**NUMBER:** 07-002-16 REV. A

Thermostat Housing Replacement

2016	(DS)	Ram 1500 Pickup
2016	(DX)	Ram Truck (Mexico)

**Fig. 1 Thermostat Housing**

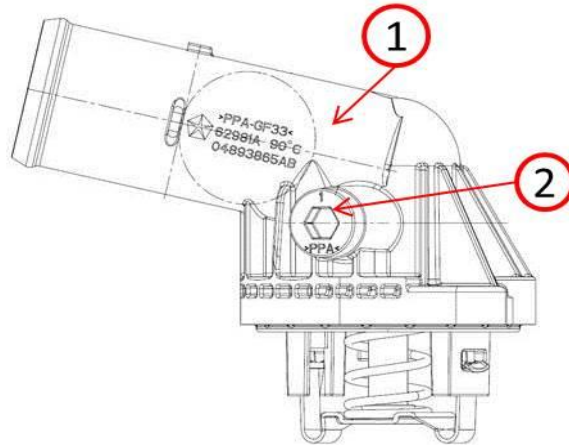
The customer may describe a coolant leak at the thermostat housing bleed screw.

1. Inspect the thermostat housing bleed screw for visible leaks (Fig. 1).
2. Is coolant leaking from the bleeder screw?
  - a. YES>>> Replace thermostat housing. Proceed to repair procedure, [Step #1](#).
  - b. NO>>> Proceed to [Step #3](#).
3. Remove the throttle body assembly to gain access to the bleeder screw. Refer to the detailed service procedures available in DealerCONNECT> TechCONNECT under: Service Info>14 - Fuel System/Fuel Injection, Gas/Throttle Body/Removal>3.6L.
4. Tighten the bleed screw to 3 N·m (26 in.lbs).
5. Does the bleed screw achieve the specified torque?
  - a. YES >> Reinstall the throttle body assembly. Refer to the detailed service procedures available in DealerCONNECT> TechCONNECT under: Service Info>14 - Fuel System/Fuel Injection, Gas/Throttle Body/Installation>3.6L. Use LOP (07 40 05 99) to close the active RRT.
  - b. NO>> Proceed to [Step #1](#).

1. Replace the thermostat housing (Fig. 1). Refer to the detailed service procedures available in DealerCONNECT> TechCONNECT under: Service Info> 07 - Cooling/Engine/Thermostat/Removal/Installation>3.6L.
